ATTACHMENT 1

EXISTING TECHNICAL SPECIFICATIONS

8903090211 890304
PDR ADDCK 05000206
P PDC

2.1 REACTOR CORE - Limiting Combination of Power, Pressure, and Temperature

Figure 2.1.1
 Safety Limits
 Temperature, Power, Pressure
 RCS Flow \geq 195,000 GPM

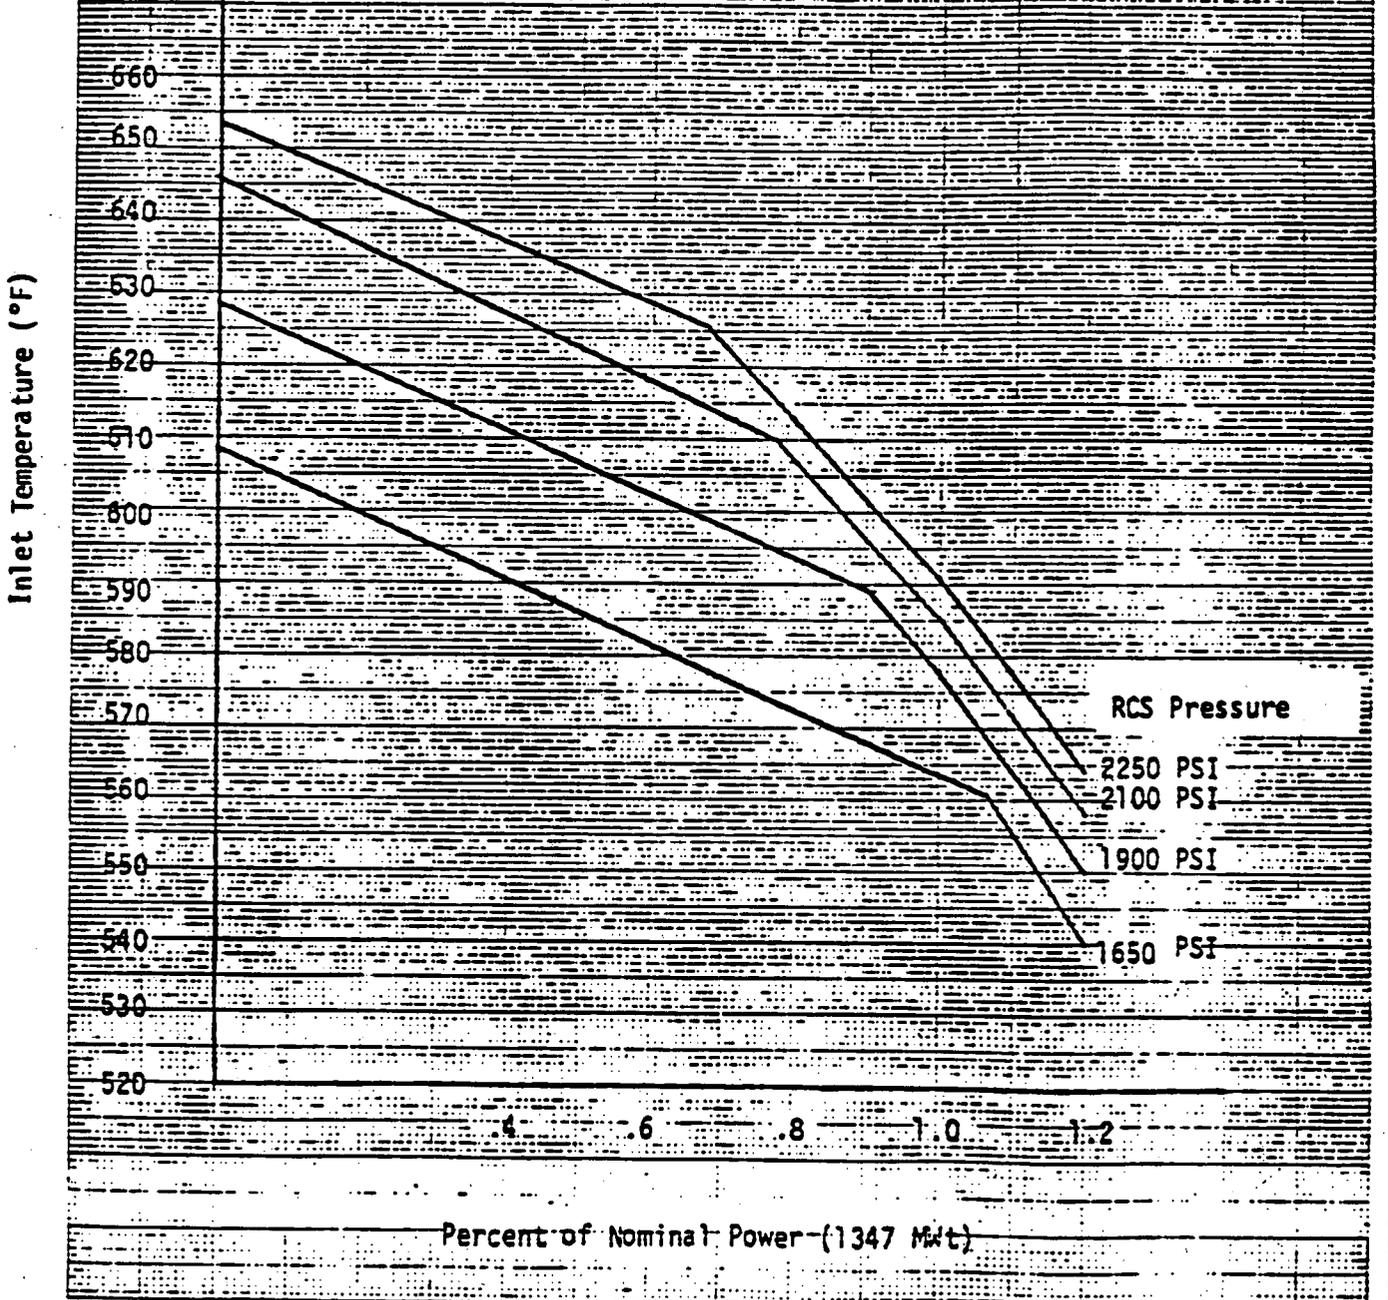
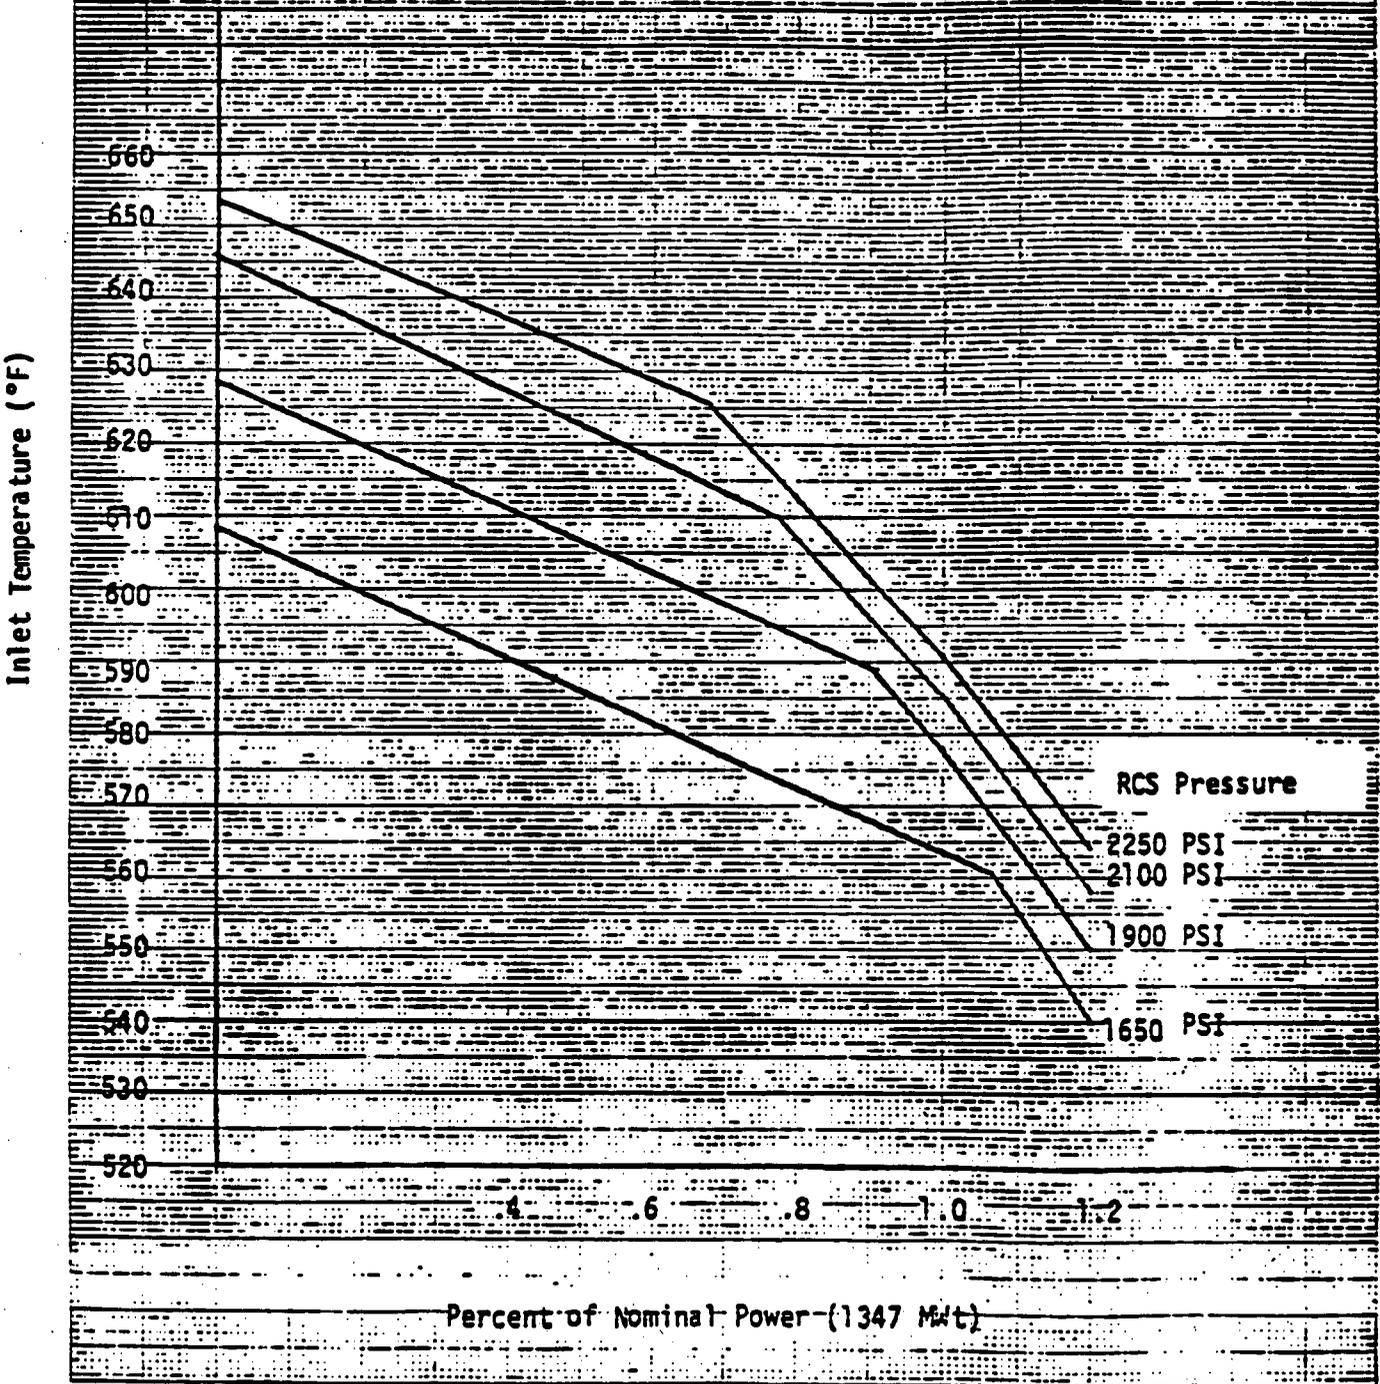
- (1) The reactor coolant system pressure shall not exceed 2735 psig with fuel assemblies in the reactor.
- (2) The combination of reactor power and coolant temperature shall not exceed the locus of points established for the RCS pressure in Figure 2.1.1. If the actual power and temperature is above the locus of points for the appropriate RCS pressure, the safety limit is exceeded.

FIGURE 3.5.2.1

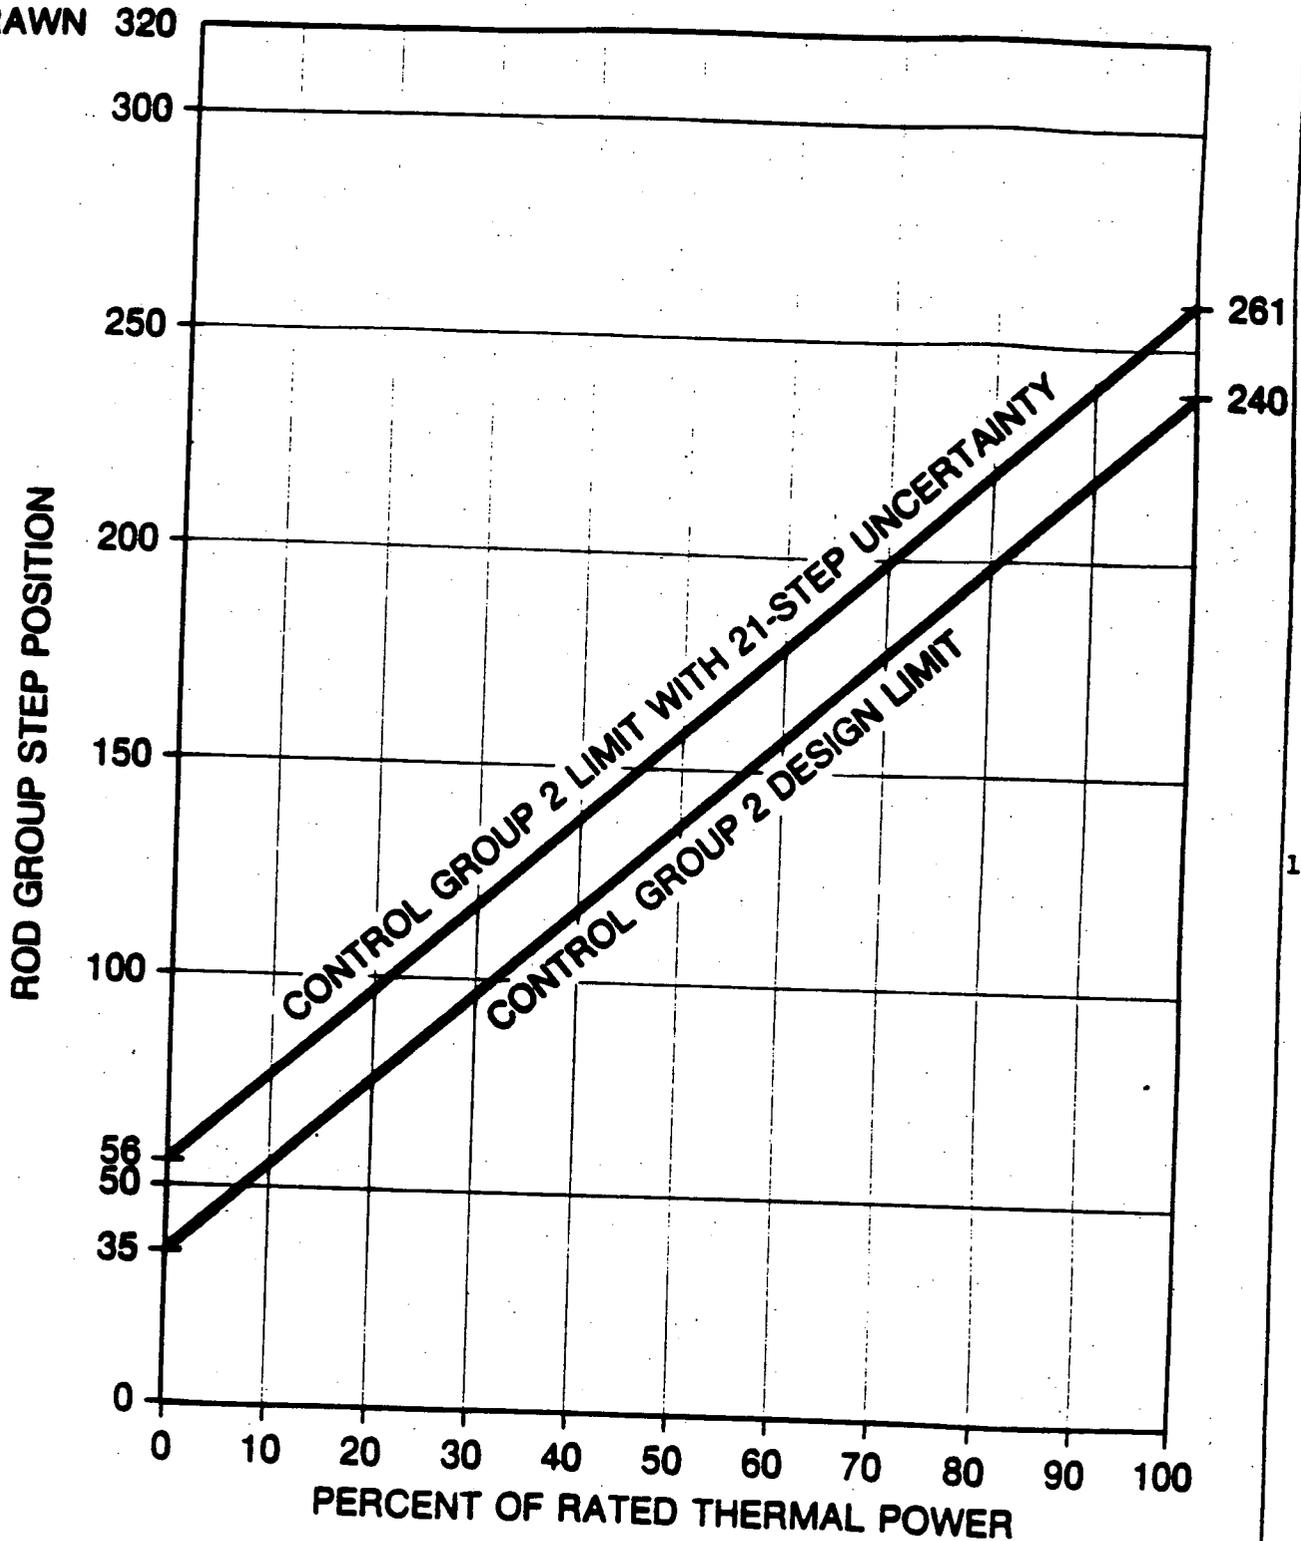
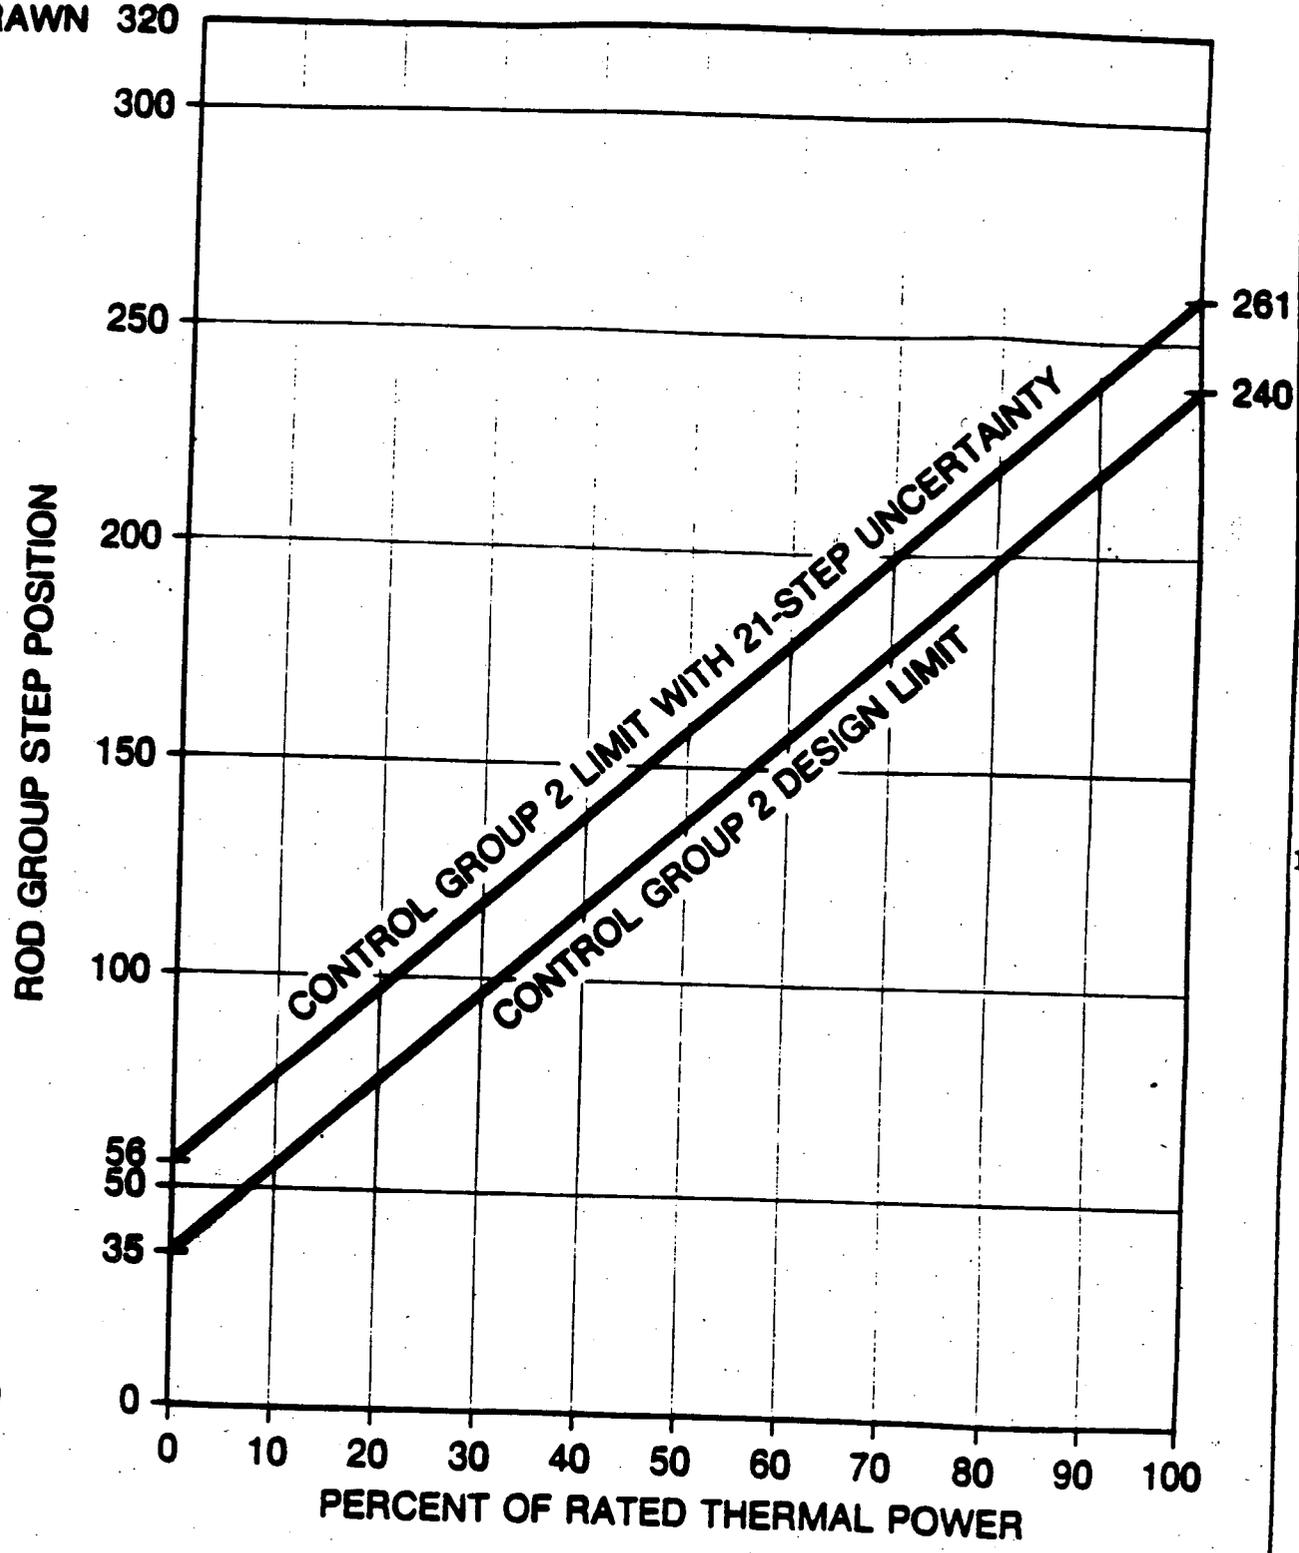
Low power physics tests are conducted approximately one to four times during the core cycle at or below 10% RATED THERMAL POWER. During such tests, rod configurations different from those specified in Figure 3.5.2.1 may be employed.
